#### **PLANNING COMMISSION**

#### **SEPTEMBER 14, 2020**

**Bigelow Voigt Eighth**

**Review of Revised Construction Plans**

INSET A BITUMINOUS ROAD SECTION

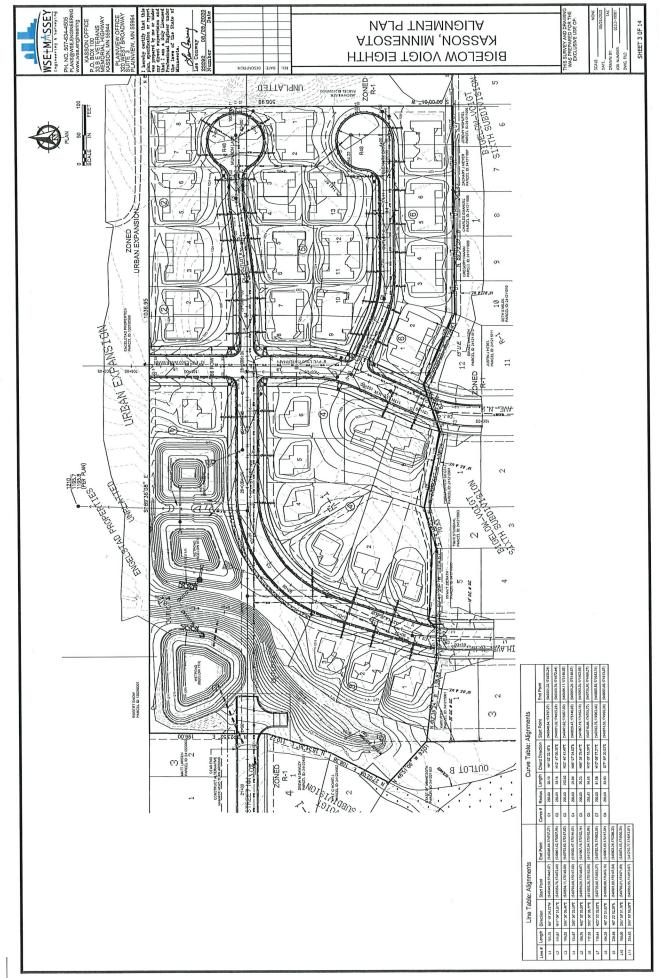
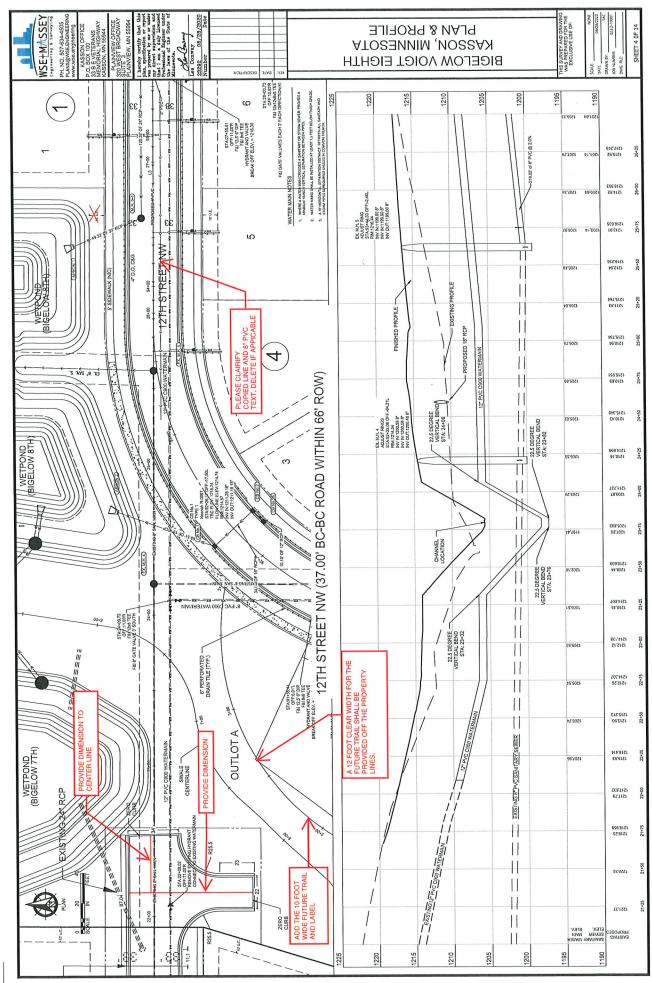
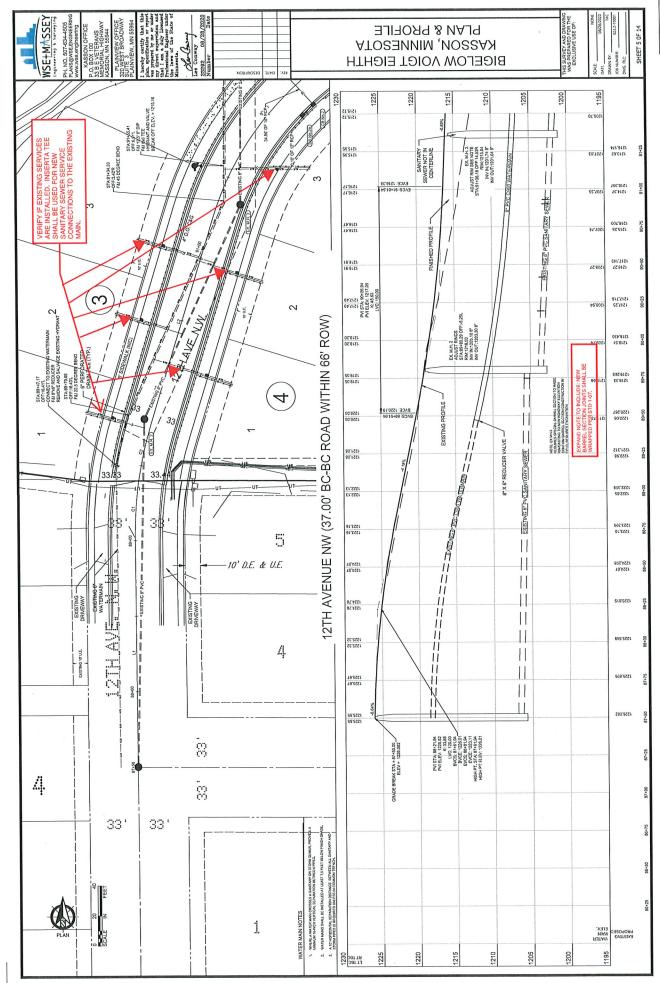
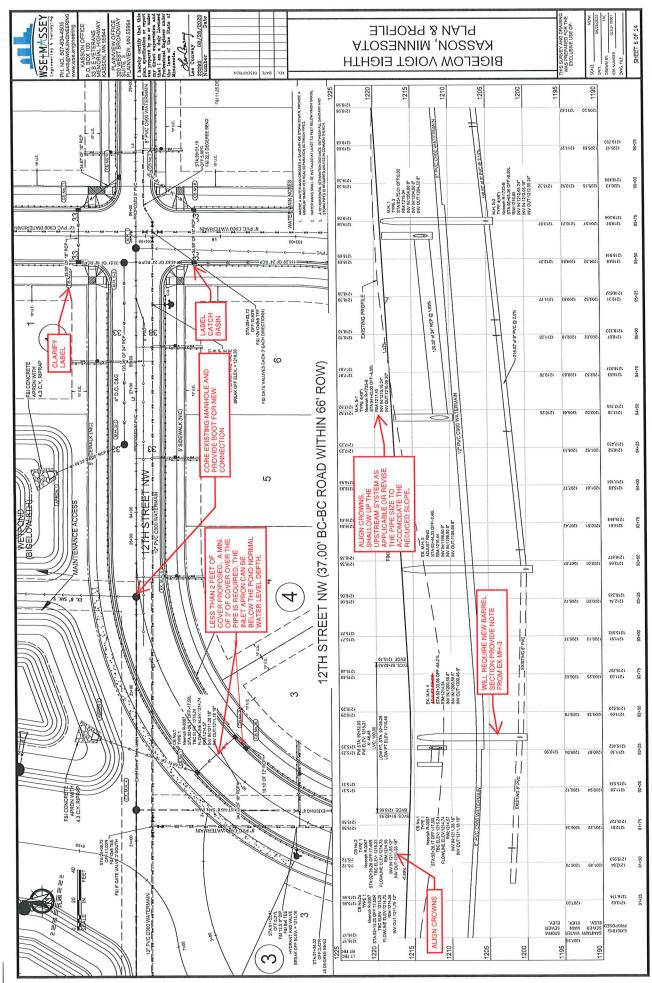
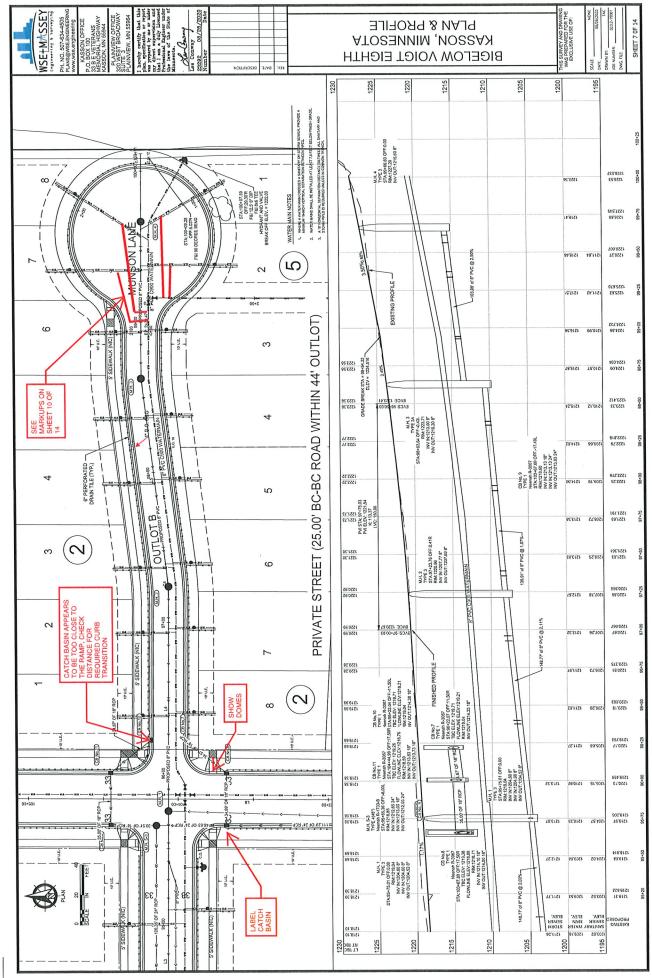
2", 2", 8", 12" road section-complies with report No plowing private streets
